**TOWN OF LOS GATOS
PLANNING COMMISSION
REPORT**

DATE: January 3, 2025
TO: Planning Commission
FROM: Joel Paulson, Community Development Director
SUBJECT: Consider a Request for Approval to Construct a New Single-Family Residence with Reduced Side and Rear Yard Setbacks, Site Improvements Requiring a Grading Permit, and Removal of Large Protected Trees on a Nonconforming Vacant Property Zoned R-1:20. **Located at 45 Reservoir Road.** APN 529-33-054. Architecture and Site Application S-22-048. Categorically Exempt Pursuant to CEQA Guidelines Section 15303: New Construction. Property Owner: Farnaz Agahian. Applicant: Gary Kohlsaas, Architect. Project Planner: Sean Mullin.

RE: 45 Reservoir Road

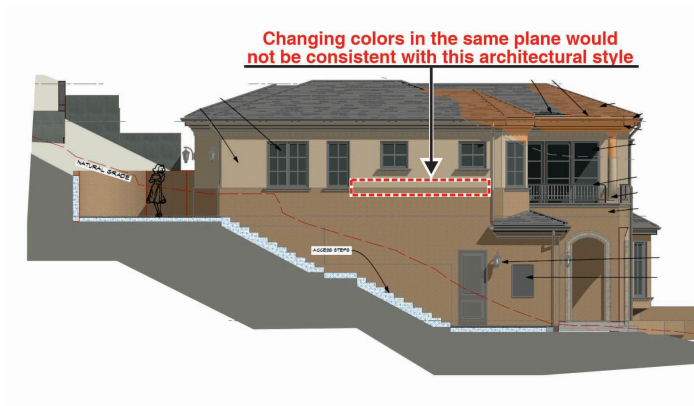
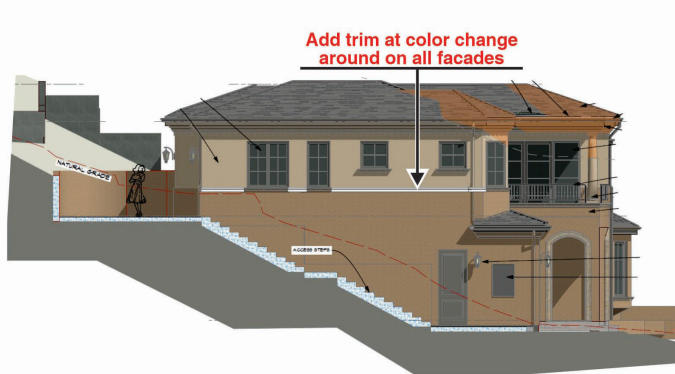
The tall side walls are not consistent with Residential Design Guideline 3.3.3.

Recommendation: Add projecting molding at the proposed color change. Note that the use of two wall colors or the use of a single color would both be acceptable - see photo examples below.

A projecting molding has been added at the horizontal color change location around the entire perimeter of the building.

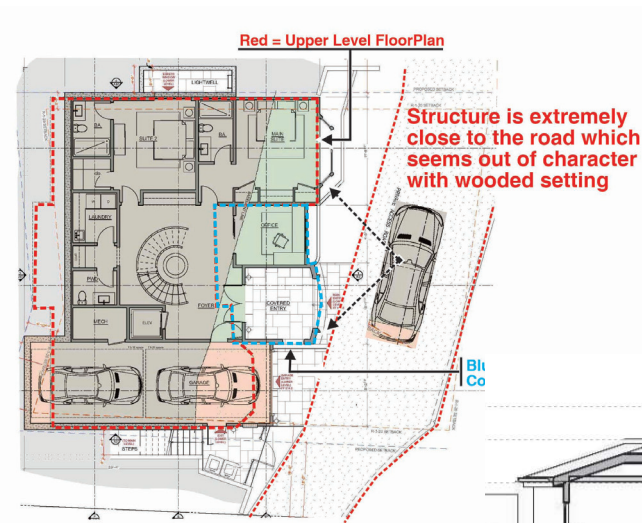
A second issue is of more concern and may not have a viable alternative aside from a smaller building footprint and volume. However, I do feel it is important to identify the issue because of its potential impact on the character of the private drive.

The issue is that the proposed house is quite close to the road and appears to be closer to the road than other nearby homes. This may be acceptable given the private access road, but it seems out of character with its current semi-rural, wooded environment - see illustrations below.

Fire Turnaround Diagram
scale: 1"=10'

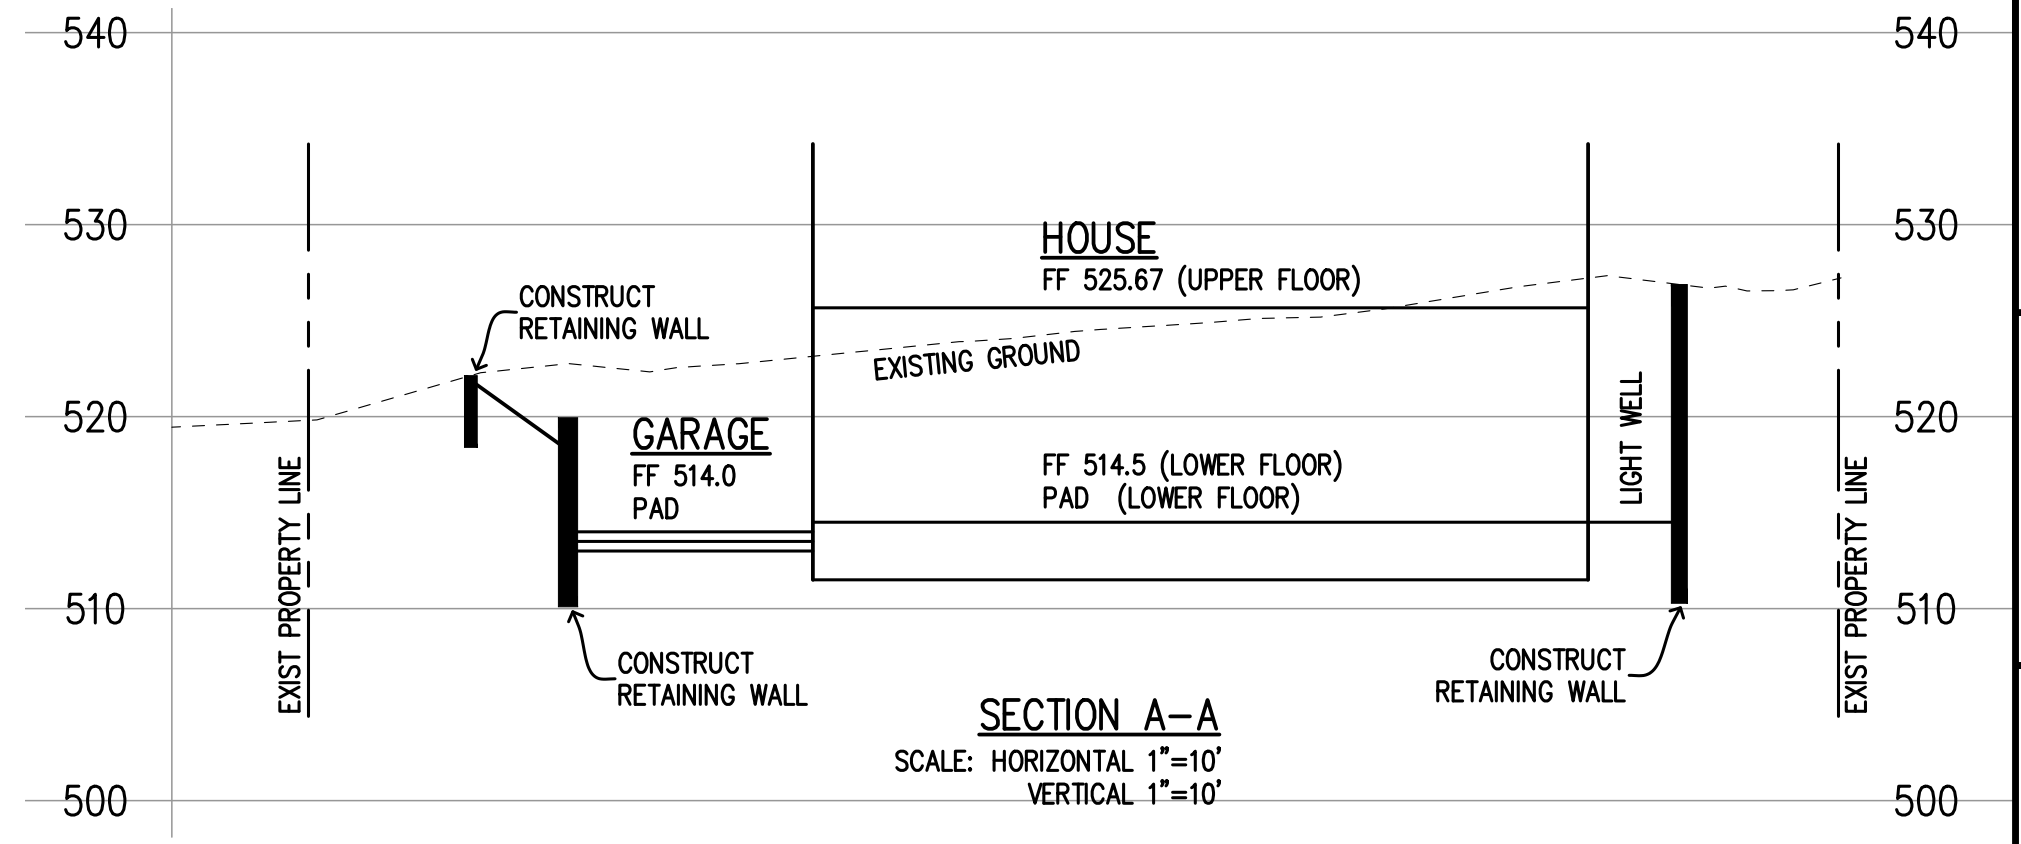
112. FIRE DEPARTMENT (ENGINE) DRIVEWAY TURNAROUND REQUIRED: (As noted on sheet A-4 and sheet 4) Provide an approved fire department engine driveway turnaround with a minimum radius of 36 feet outside and 23 feet inside. Maximum grade in any direction shall be a maximum of 5%. Installations shall conform with Fire Department Standard Details and Specifications D-1. CFC Sec. 503.
-Approved Request of Exception PC 24-2558. See comment number 108 for conditions of approval.
